PLAN 2

PLANNING APPLICATION P17-127

17 MALCOMBE STREET, LONGFORD

Additional Information Required for Planning Application P17-127 - Multiple dwellings x4 (inc. existing dwelling), carport & additional access at 17 Malcombe Street, Longford

Site Plan - Plumbing
Drawing No. 170405

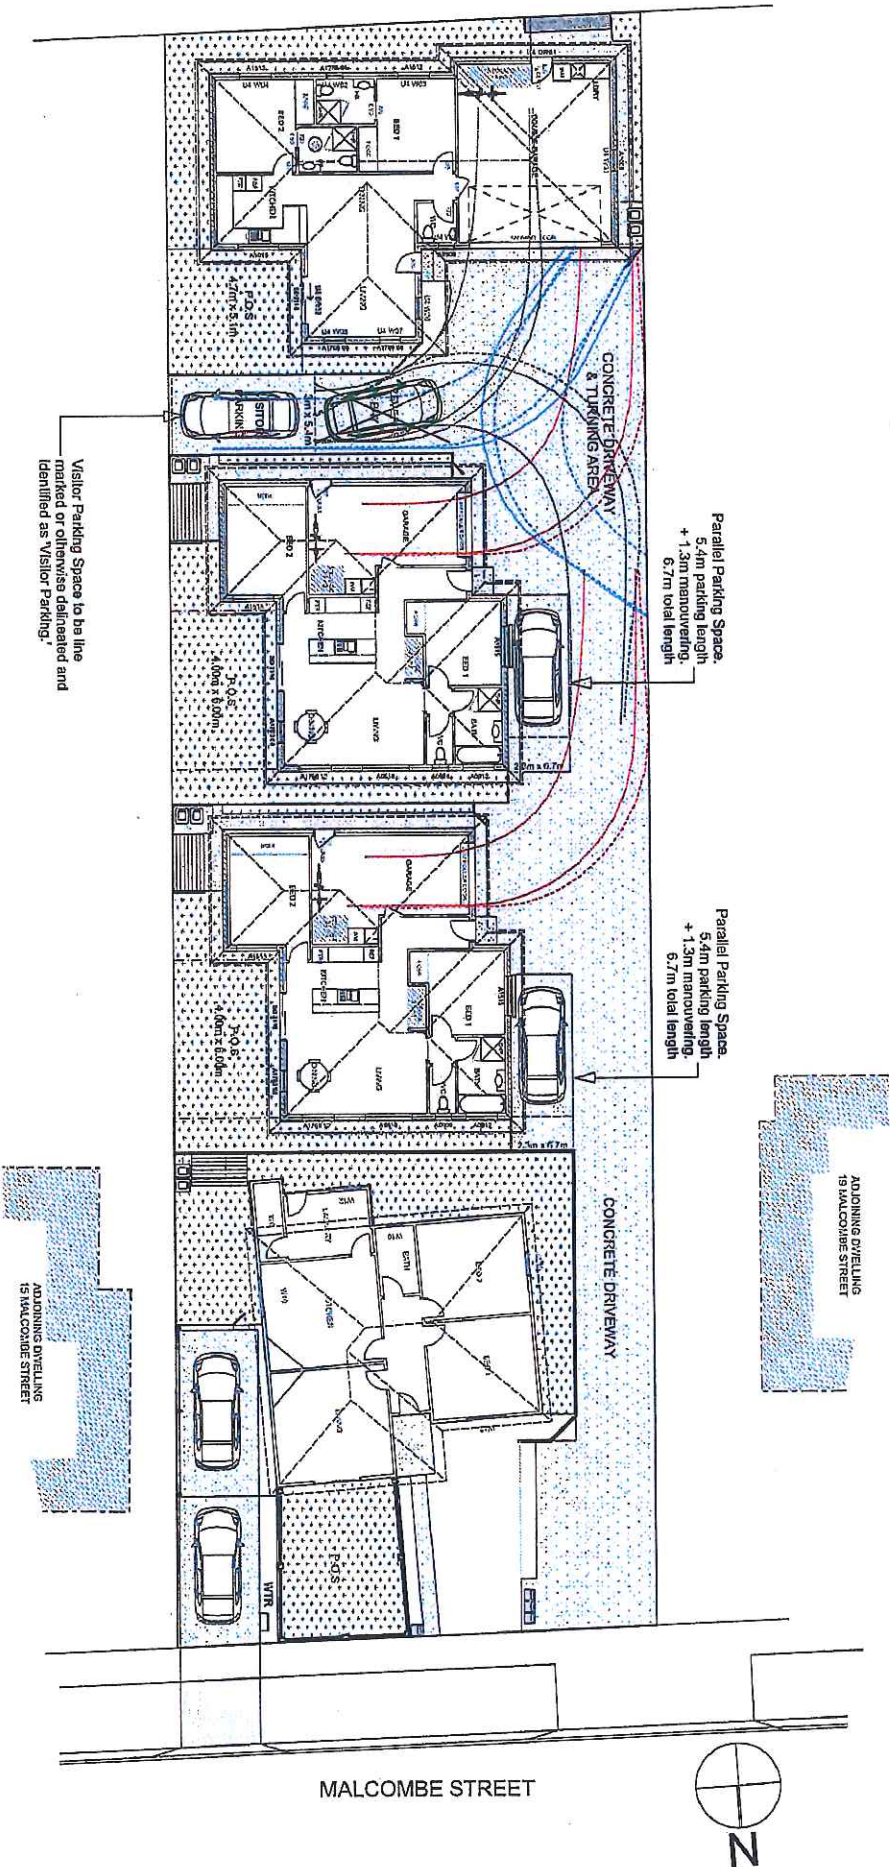
I note that the turning templates provided show the visitor park turning area (shown in blue) utilising area marked as 'private area' for unit 3. This also occurs with unit 2 impinging on unit 3's 'private area'. I also note that the eastern garage parking space of unit 4 (shown in green) utilises the visitor parking space to straighten. A revised turning template is required to show this movement can occur while the visitor parking space is occupied.

Visitor Parking Space to be line marked or otherwise delineated and identified as 'Visitor Parking'.

Shadow Diagrams

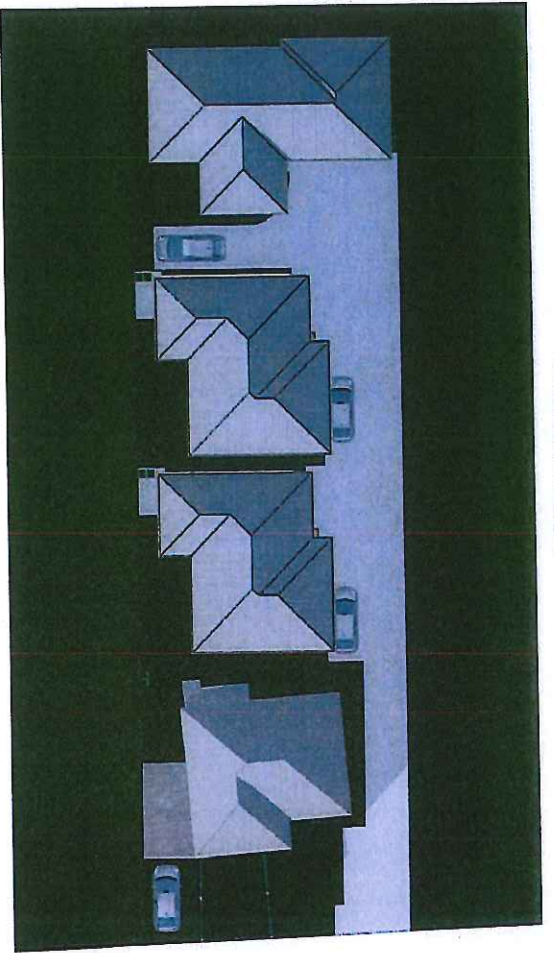
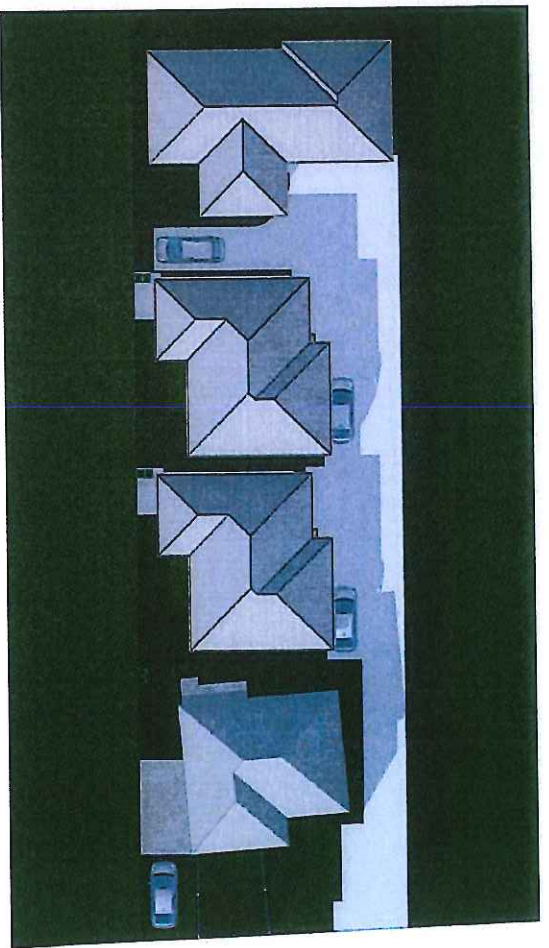
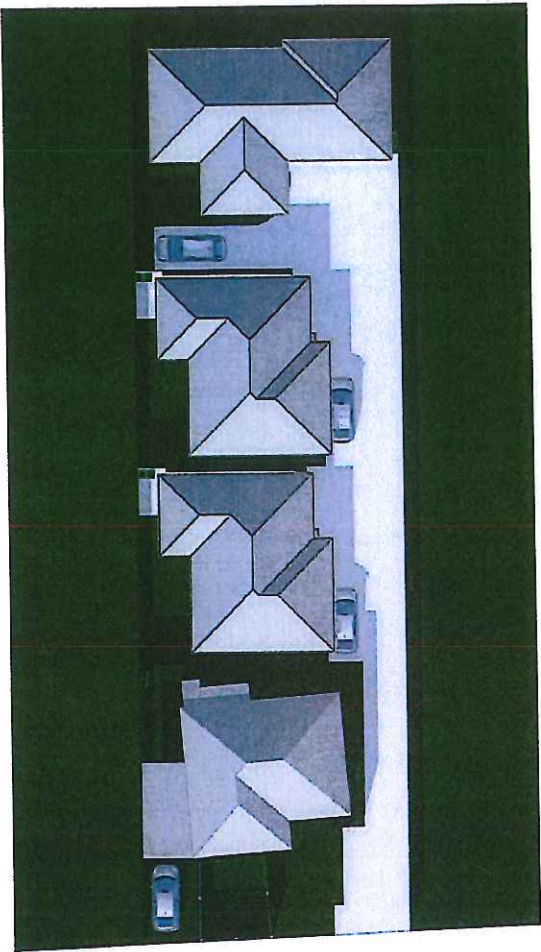
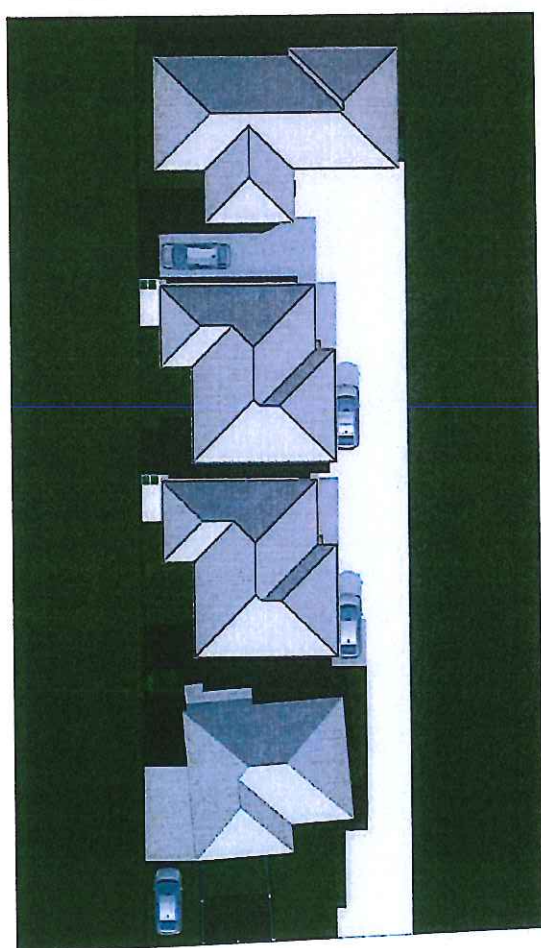
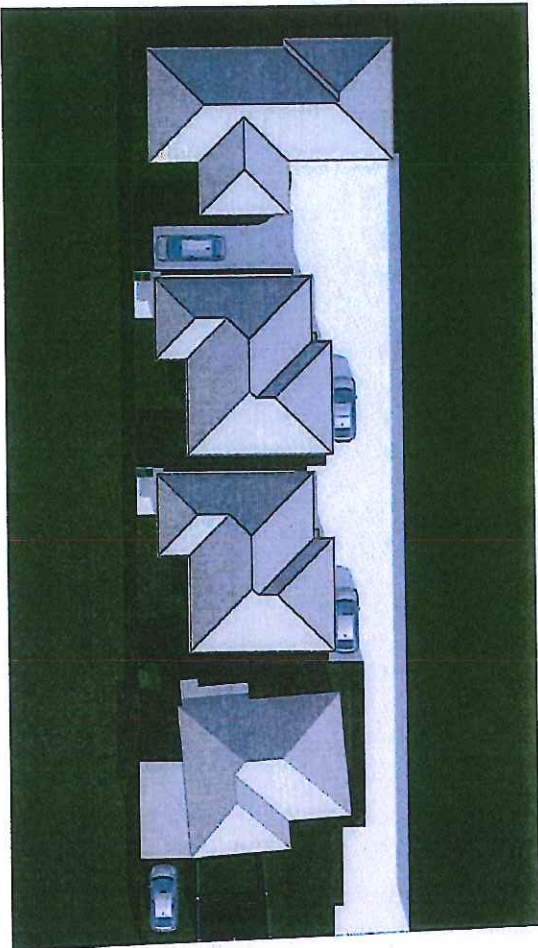
- **Shadow Diagrams**
In order to demonstrate compliance against clauses 10.4.2 A3 and 10.4.4 A2 & A3 (or corresponding performance criteria), please provide shadow diagrams for each unit.

A1 Compliant The living area windows of all dwellings are within 30 degrees of north. Ref. additional shadow diagrams confirming solar access June 21st.

A2 Compliant Unit 1 & Unit 4 have >3m separation to northern orientated windows. Unit 2 & Unit 3 Ref. additional shadow diagrams confirming compliance.
